# CITY OF ALBUQUERQUE

RE: **Lot 24 Block 5 Unit 5 SAD 227**  
**Volcano Cliffs**  
**8008 Victoria Rd. NW**  
**Grading and Drainage Plan**  
**Engineers Stamp Date 3/24/2021 (E10D094)**  
**Pad Certification Date 6/8/2021**

## DRAINAGE AND TRANSPORTATION INFORMATION SHEET (REV 6/2018)

ENGINEER'S SEAL  3/24/21 DAVID SOULE P.E. #14522	LOT 24 BLK 5 UN 5 VC 8008 VICTORIA DRIVE  GRADING AND DRAINAGE PLAN   P.O. BOX 53924 ALBUQUERQUE, NM 87199 (505) 321-9099	DRAWN BY DEM DATE 3-23-21 LOT 24 BLK 5 UN 5 VC.DWG
		SHEET # C1 JOB #

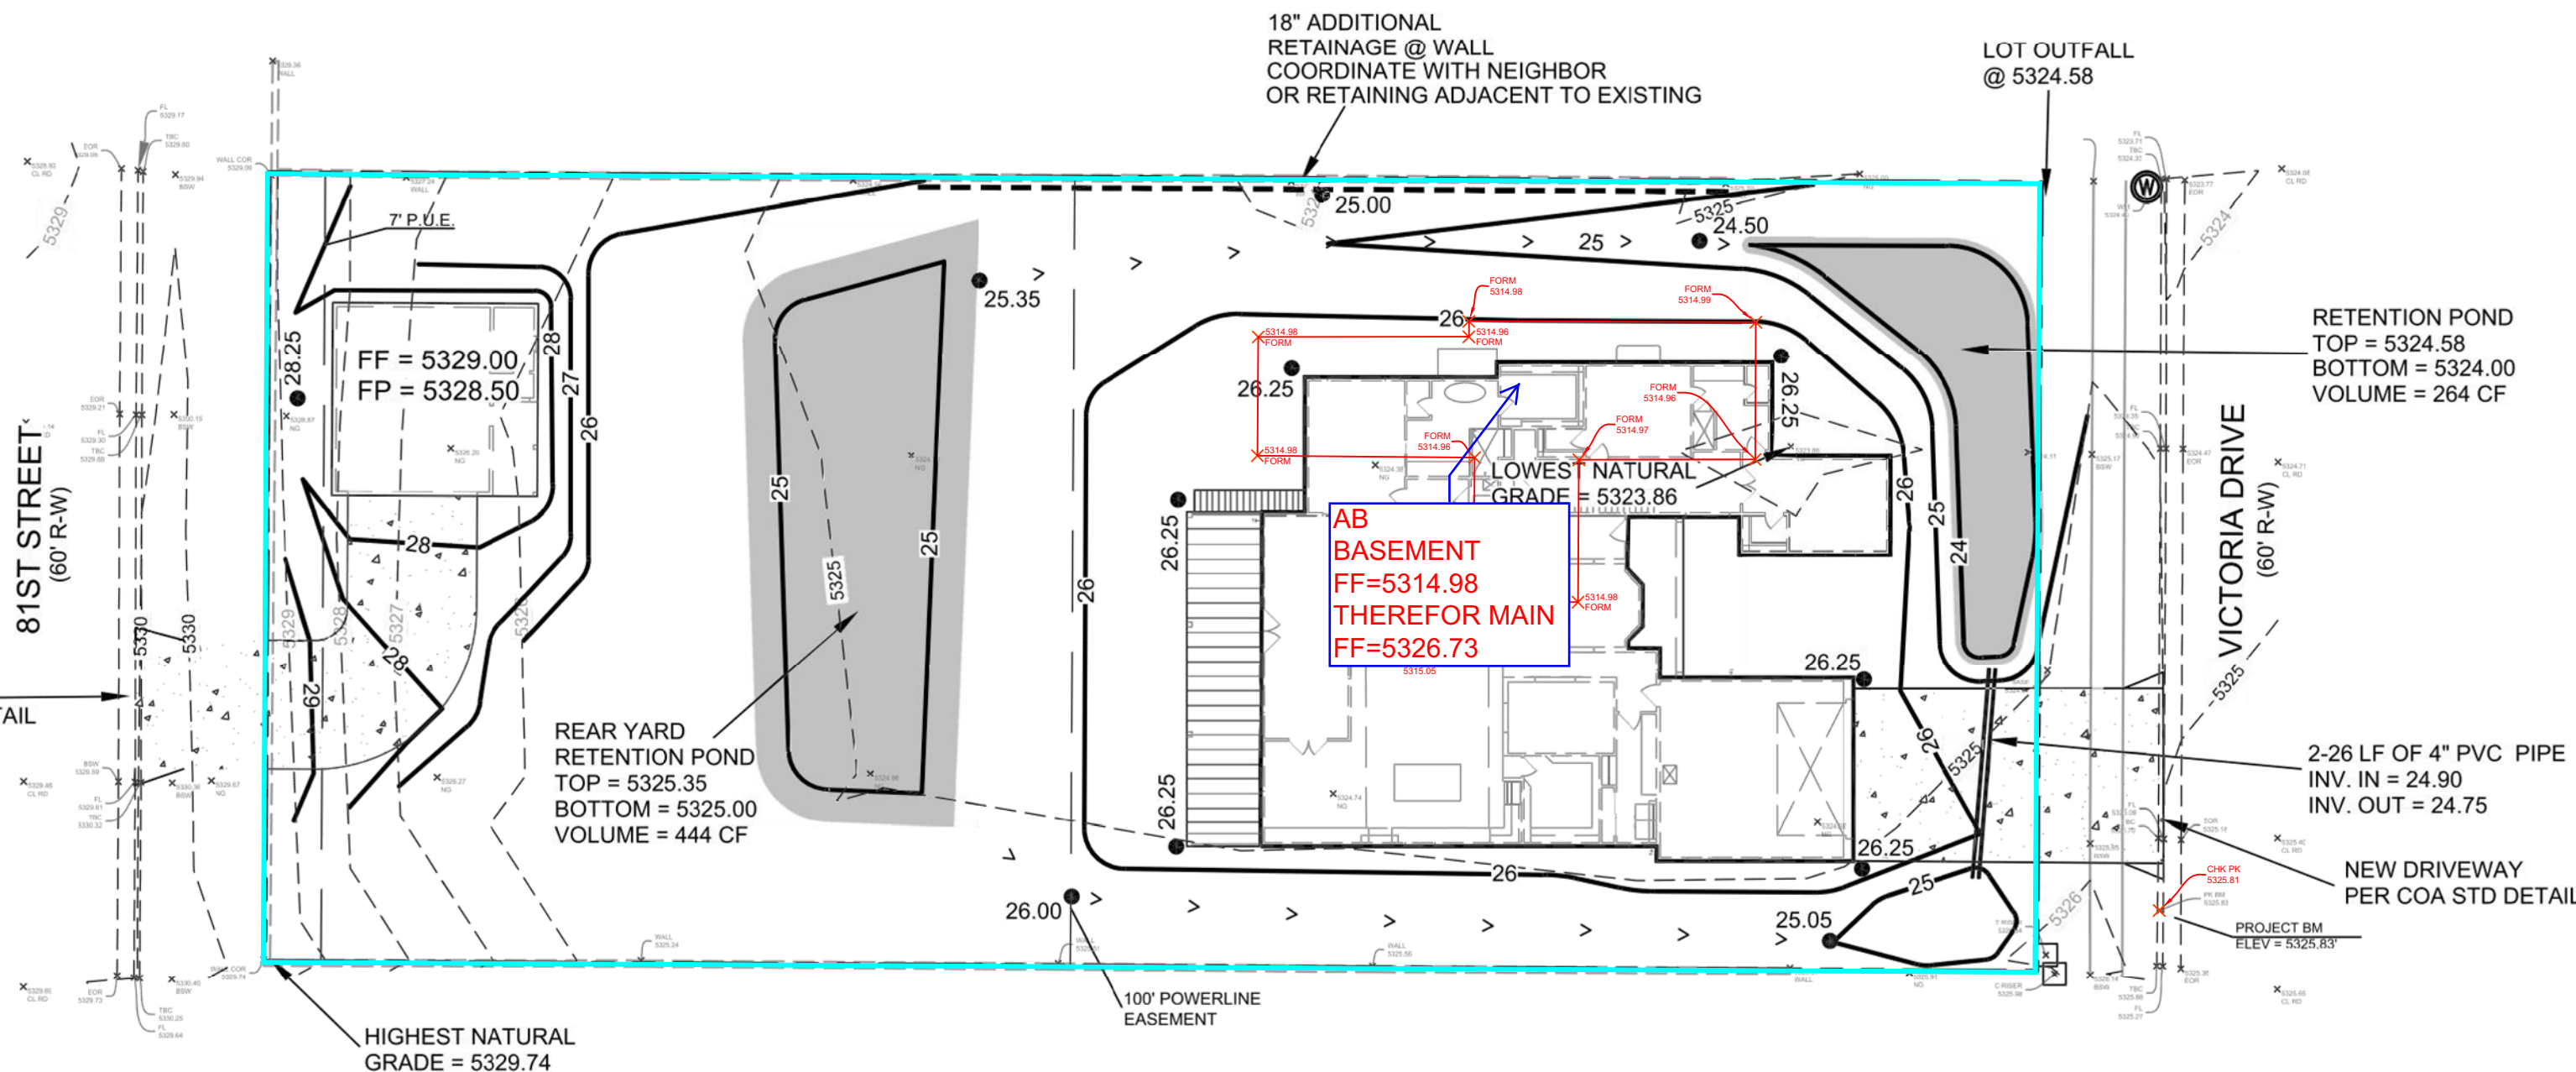
Based upon the information provided in your submittal received 6/9/2021, this plan is approved for Building Permit.

**Reiterate to the Owner/Contractor that a separate permit for a garden/retaining wall must be obtained, with the approved G&D plan. Also, advise the owner/contractor not to use dirt as a ramp to climb the curb. If dirt is used it will cause a delay in permitting.**

Prior to Certificate of Occupancy release, Engineer Certification per the DPM checklist of this plan will be required.
